TITLE:	Compatibility with the PCIe MMPT ECN
DATE:	<p>Introduced date (12/12/2023)</p> <p>Updated date (3/18/2024)</p> <ul style="list-style-type: none"> Fixed typo in section 8.2.8.4.3 Mailbox Capabilities Register in the Type field description. <p>Updated date (3/7/2024)</p> <ul style="list-style-type: none"> In sections 8.2.8.1 CXL Device Capabilities Array Register and 8.2.8.4.3 Mailbox Capabilities Register, add clarification in the Type field that CXL only defines bits 26:24. <p>Updated date (2/2/2024)</p> <ul style="list-style-type: none"> Add PCIe Base Specification v6.2 as [PCIe] and changed references from [PCIe MMPT ECN] to [PCIe]. Updated Implementation note in Section 8.2.8 to clarify how updated SW enumeration of CXL defined capabilities. Changed field definitions from “Reserved” to “Refer to [PCIe] for the definition of this field” for clarity. Restored statement that mailbox can be reset via CXL reset. <p>Updated date (1/9/2024)</p> <ul style="list-style-type: none"> Fixed the PCIe MMB MCAP ID to 01h in the implementation note in Section 9.20.

AFFECTED DOCUMENT:	CXL v3.1
SPONSOR:	Intel, Dell, Lenovo

Figure xx PCIe MCAP / CXL Compatibility

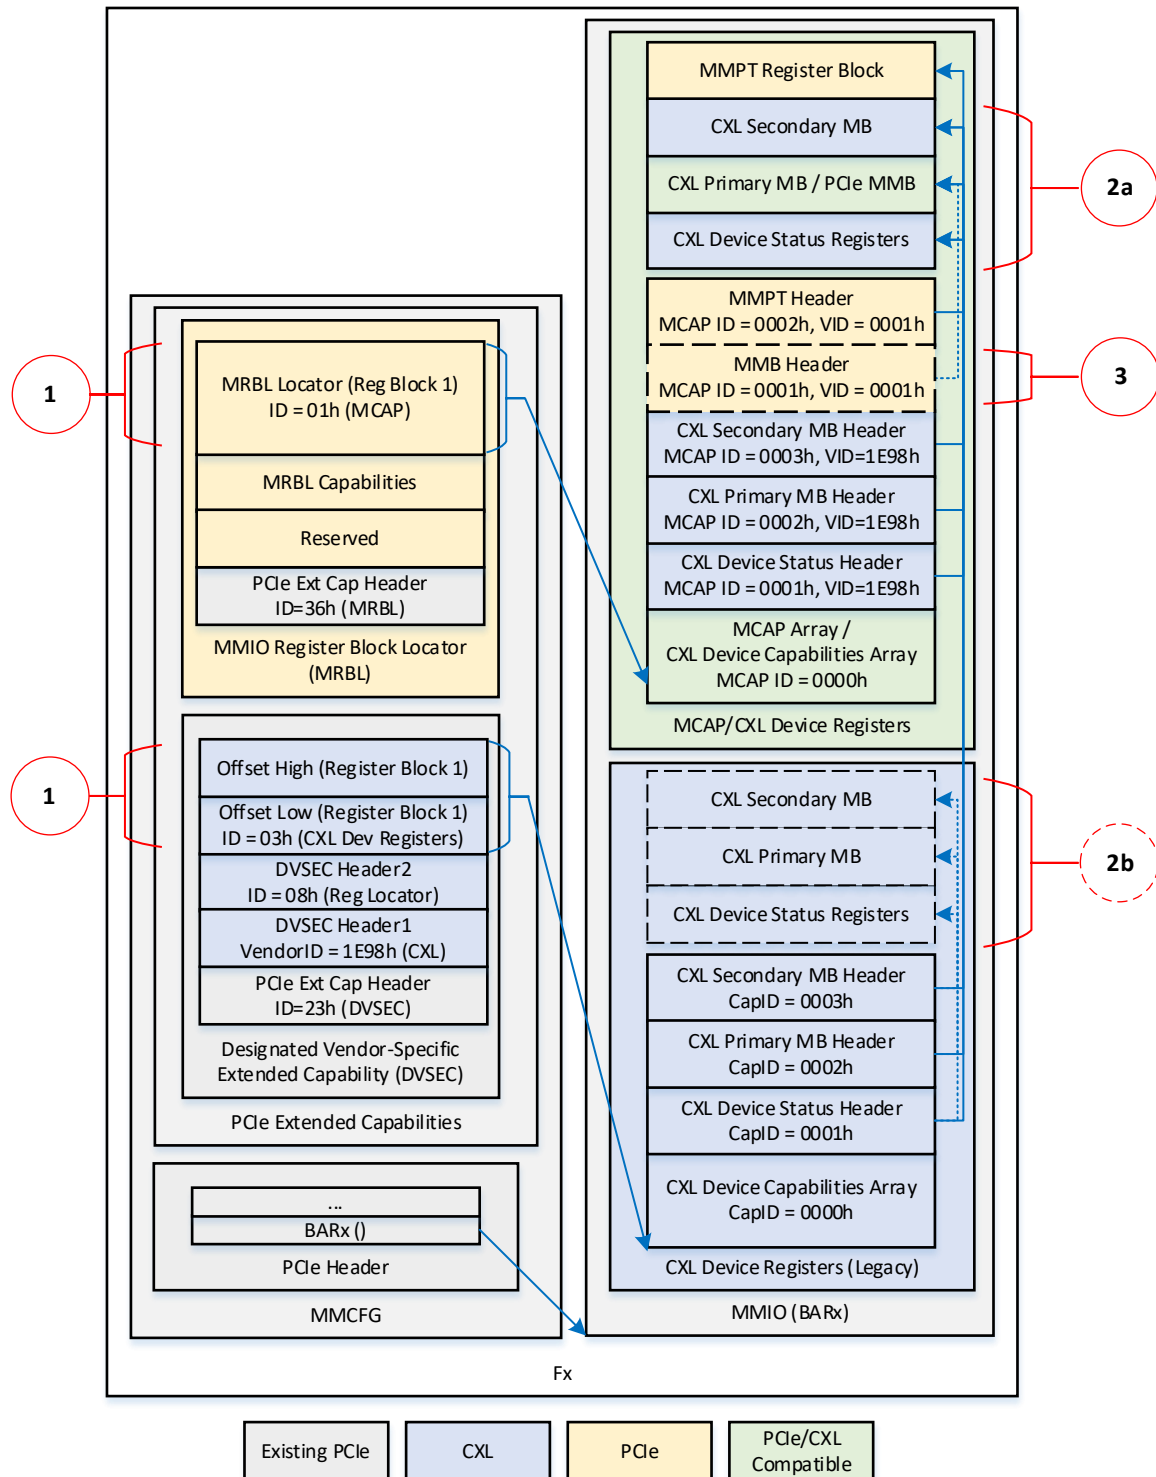
CXL components are expected to transition to the PCIe standard MCAP Register Block to enumerate CXL defined capabilities. When doing so, CXL components are required to maintain compatibility with legacy CXL software as portrayed in Figure XX.

1. CXL components are required to advertise CXL defined capabilities in both the legacy CXL Device Capabilities Array and the PCIe MCAP Array. Legacy CXL software discovers the CXL Device Capabilities Array using the entry in the CXL Register Locator DVSEC with Register Identifier = 03h (CXL Device Registers). Updated software discovers the PCIe MCAP Array using the entry in the PCIe MMIO Register Block Locator (MRBL) Extended Capability with Register Block Identifier = 01h (MMIO Capabilities). Updated SW should check the PCIe MCAP Array first and only fallback to the legacy CXL Device Capabilities Array if it's not supported.
2. While CXL defined capabilities must be advertised in both the legacy CXL Device Capabilities Array and the PCIe MCAP Array, CXL components may choose to implement the register

structures for CXL defined capabilities in one of the following ways. In either case, legacy software locates the register structure from the offset specified in the header in the legacy CXL Device Capabilities Array. Updated software locates the register structure from the offset specified in the header in the PCIe MCAP Array.

- a. CXL components may alias the location of CXL defined capabilities specified in the legacy CXL Device Capabilities Array and the PCIe MCAP Array to a single instance of the register structure. In this case, the CXL Device Capabilities Array, the PCIe MCAP Array, and the register structures are required to be located in the same PCIe BAR and both the CXL Device Capabilities Array and the PCIe MCAP Array must be located below the register structures.

- b. CXL components may choose to implement two instances of the register structures for CXL defined capabilities; one located from the offset specified in the header in the CXL Device Capabilities Array and one located from the offset specified in the header in the PCIe MCAP Array. Updated software is required to use the instance of the register structure located via the PCIe MCAP Array.

3. CXL components that support both the CXL primary mailbox and the PCIe MMB are required to alias the PCIe MMB (Vendor ID = 0001h and MCAP ID = 0001h) to the CXL Primary Mailbox registers. Refer to Section 9.20 for complete details.
